UNITED STATES PATENT AND TRADEMARK OFFICE

APPLICATION NO.	FILING DATE	FIRST NAMED INVENTOR	ATTORNEY DOCKET NO.	CONFIRMATION NO.
10/552,229	10/07/2005	Wolfgang Dinkelacker	K0004/7006	6706

Office Action Summary

DETAILED ACTION

**FIG. 15****Claim Rejections - 35 USC § 103**

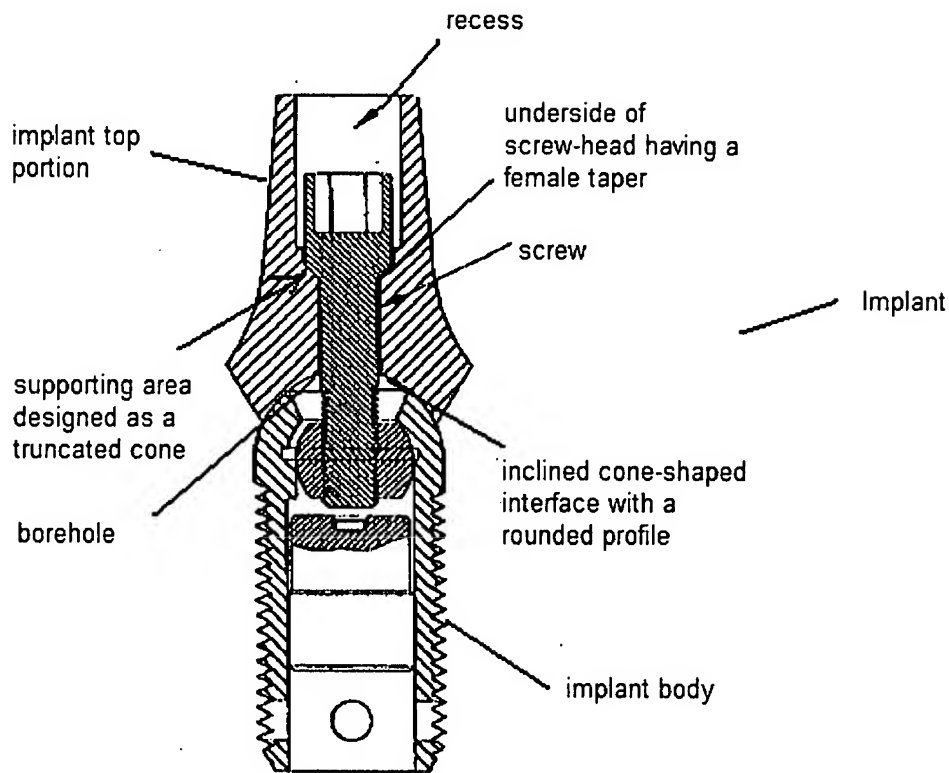
Lustig et al. discloses an implant having: an implant top portion (See Fig. Below) attached to an implant body (see Fig. Below) by means of screw (see Fig. Below); a borehole that surrounds a through-borehole (825 and 915) for connection screw and a recess (see Fig. Below) with a supporting area designed as a truncated cone (Shown in Figure below)(Fig. 1-17) for the screw head; a screw head having an underside that is designed as a female taper shown in Fig. 15 (reproduced in the Figure below); an implant top that is adapted to the profile of the implant body by means of a screw (Column 2, Lines 58-67). It is inherent that the female taper and the truncated cone are brought into close contact when the connection screw is tightened. Lustig et al. further discloses an implant where the interface between the implant body and the implant top portion has a head that runs at a right angle to the longitudinal axis of the implant body (Figs. 15 and 43c); an interface between the implant body and the implant top that has a

profile adapted to a comb shape of the jaw (Fig. 43c); a profile that is inclined toward the buccal side and the lingual side (Fig. 43c); and where the profile toward the buccal side and the lingual side is circularly rounded and also has a bell shape (Figs. 1-17, 43b and 43c). Lustig further discloses a jaw implant where the inclined faces of the buccal side and on the lingual side in the interface area of the implant body form an angle, which is larger than the angle between corresponding inclined surfaces on the buccal side and the lingual side in the interface area of the implant top portion; and where the rounded surface on the buccal side and the lingual side have a smaller radii of curvature in the interface area of the implant top portion than the corresponding rounded surfaces on the buccal side and on the lingual side in the interface area of the implant body (Figs. 15-17, 43b and 43c).

Applicant argues that the undercut of Lustig's screw has a different form and purpose than the female taper of the present invention. However, it has been held that a recitation with respect to the manner in which a claimed apparatus is intended to be employed does not differentiate the claimed apparatus from a prior art apparatus satisfying the claimed structural limitations. See *Ex parte Masham*, 2 USPQ2d 1647 (1987). Lustig discloses the structural limitations of the jaw implant having a recess forming a supporting area in the shape of a truncated cone; and a connecting screw having a female taper at the underside of the screw head in order to mate with the supporting area. This is clearly shown in Figure 15, which is reproduced below.

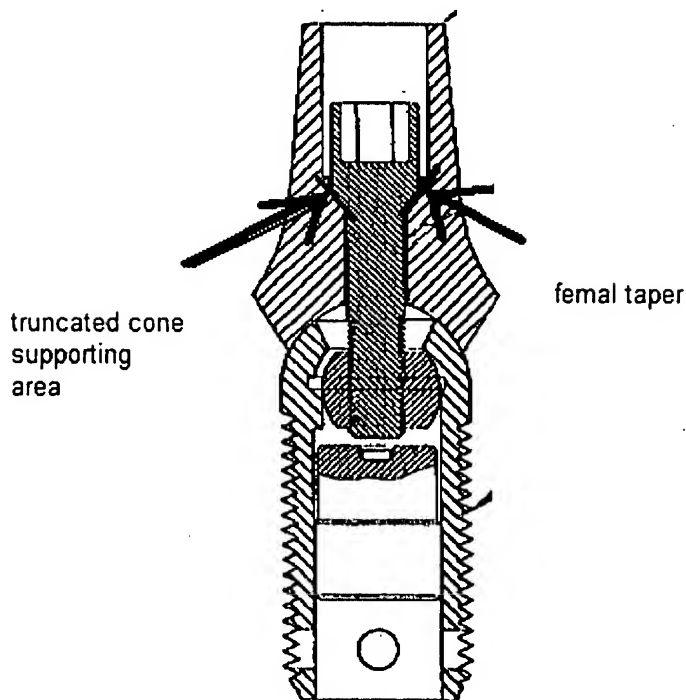
The figure illustrated above shows the recess having a supporting area designed as a truncated cone and a connection screw having a corresponding female taper that mates with the supporting area.
